Project title	RFD 2022 Major Flood Model Update Mary River (MAR) Catchment
Job number	305456-00
File reference	Peer Review Technical Note
cc	Alana Mosely
Prepared by	Greg Rogencamp, Kok Keng Tan
Date	3 February 2025
Subject	Independent Technical Review – Technical Note

Subject Flood Model Verification Record

Project Name	RFD 2022 Major Flood Model Update Mary River (MAR) Catchment	Date	2/12/2024
		Version	2

Representative cross section:

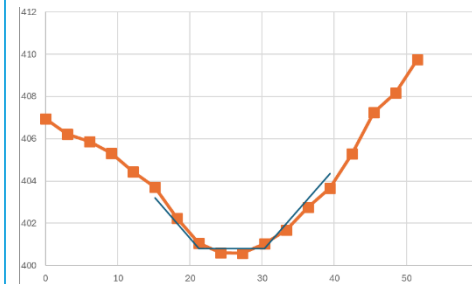
<p>ARF applied correctly</p>	<p>ARF factors applied for this catchment only captured area range from 5km² to 75km² (ARFc to ARFe). This approach would lead to an underestimation across the upstream watercourses. However, the example presented in report for MAR037_00000 indicated that, despite the significant underprediction in peak flows, the relative reduction in flood depth is insignificant.</p> <p>Overall, this approach is deemed an acceptable compromise.</p> <p>2/12/24: Response noted.</p>	<p>This analysis has been furthered and updated subsequent to the document provided for the independent review, as summarised here:</p> <p>As a sensitivity, WBNM was run with no ARF (ARF = 1). Differences in flow was then checked for the critical storm for several events. It was found that peak flow difference was less than 10% for the 5% and 1% AEP storms, and was 15% for the 1 in 1000 and 1 in 2000 AEP storms.</p> <p>The largest difference in ARF value was noted as the 1 in 2000 AEP 10 minute storm (which is noted to be not a critical duration for the catchment). This resulted in a 35% difference in peak flow (magnitude of 6.5m³/s difference, total flow of 18.7m³/s with ARF=1).</p> <p>These flow changes were tested in a representative cross-section per below, utilising Manning's equation (assuming a channel roughness of 0.057). The results indicate 30mm or less difference in depth for the 5% and 1% AEP critical storm events (depth approximately 0.9m), and 100mm difference for the 1 in 1000 and 1 in 2000 AEP critical storm events (total depth approximately 1.3m).</p> <p>This was repeated for a channel with a roughness value of 0.03. Difference in depth was 20mm or less difference for the 5% and 1% AEP critical storm events (depth approximately 0.6m), and 80mm difference for the 1 in 1000 and 1 in 2000 AEP critical storm events (total depth approximately 0.9m).</p> <p>Regarding the larger (approximately 100mm) difference for the more rare storms, it is noted that</p>	<p>Commentary. No action</p>	<p>Closed</p>

the Pilot study indicated that differences in this order of magnitude could occur if picking a sub-selection of storms for modelling in TUFLOW (as compared to running all storms in TUFLOW). This was considered a tolerable outcome when noting the benefits of running a sub-selection of storms chosen from a HEH model as compared to running all in TUFLOW. Thus, whilst not ideal, the 100mm difference in the MAR model as a result of ARF C (instead of ARF A) for the larger and more rare storms is considered acceptable.

Council will consider in the next model update if adopting more conservative ARF values is more appropriate for this catchment.
